RE: Conservation Consultee Comments

26/01257/DOC - Details Reserved by Condition 4: (Retention of all 4-panel doors) of Listed Building Consent 25/02331/LBC granted 14/04/2026

26/01352/DOC - Details Reserved by Condition 6: (Fire and Acoustic floor separation details) of Listed Building Consent 25/02331/LBC granted 14/04/2026

26/01456/DOC - Details Reserved by Condition 5: (Internal joinery and studwork) of Listed Building Consent 25/02331/LBC granted 14/04/2026

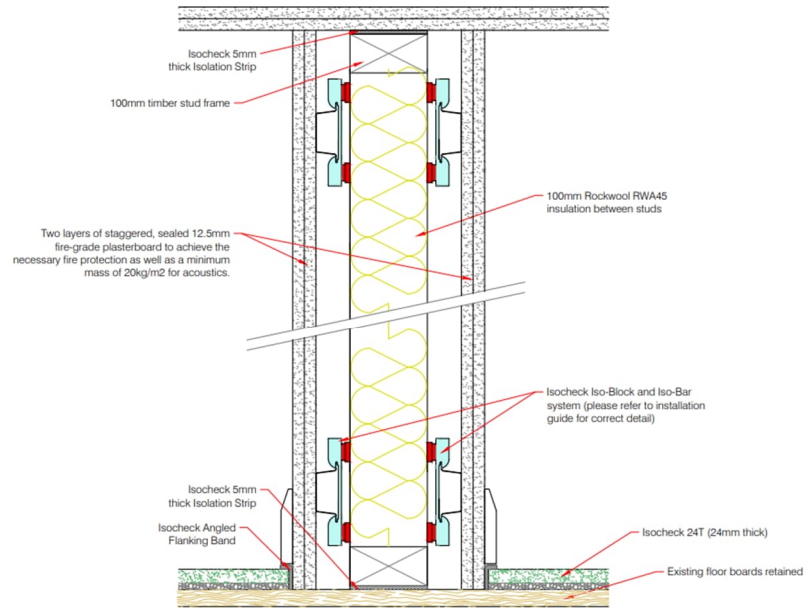
.... I note the floor separation system proposed between the commercial and residential units. I cannot say whether the existing ceilings are lath-and-plaster or not but the downside of a mixed-use conversion is that fire separation is a key requirement. I reluctantly accept the under-drawing works at ground floor; however, I note that Isocheck 24T mating only would be deployed to the existing flooring between the residential units on the first floor.

To be honest, I am a little confused as to what is being proposed.

The drawings below have been submitted together with drawing no. 102 Rev C (Feb 2026) and a document from British Gypsum showing Standard Details. It is with reference to the Standard British Gypsum Details that a ground floor area has been circled on drawing no. 102 Rev C. If a GypWall Single Frame is being proposed here what is the relevance of the image below left as both are separating wall details? I accept that a fire/acoustic wall will need to be erected as per the approved plans, but this submission does not clarify the extent of works (if any) proposed directly to the underside of the stairs as referred to in the condition. I am also unsure as to whether my comment on 9 December 2025 that '*ISOcheck 24T mating only would be deployed to the existing flooring between the residential units on the first floor*', is still the case. **Once again, I am reluctant to support this condition being signed off until clarification is given regarding a.) whether the underside of the staircase is to be sensitively handled, b) the type of wall system to be deployed at ground floor (this is, however, likely to be acceptable) and c) the extent of works covered by the image below right – is the under-drawing limited to ground floor ceilings separating commercial from residential.**
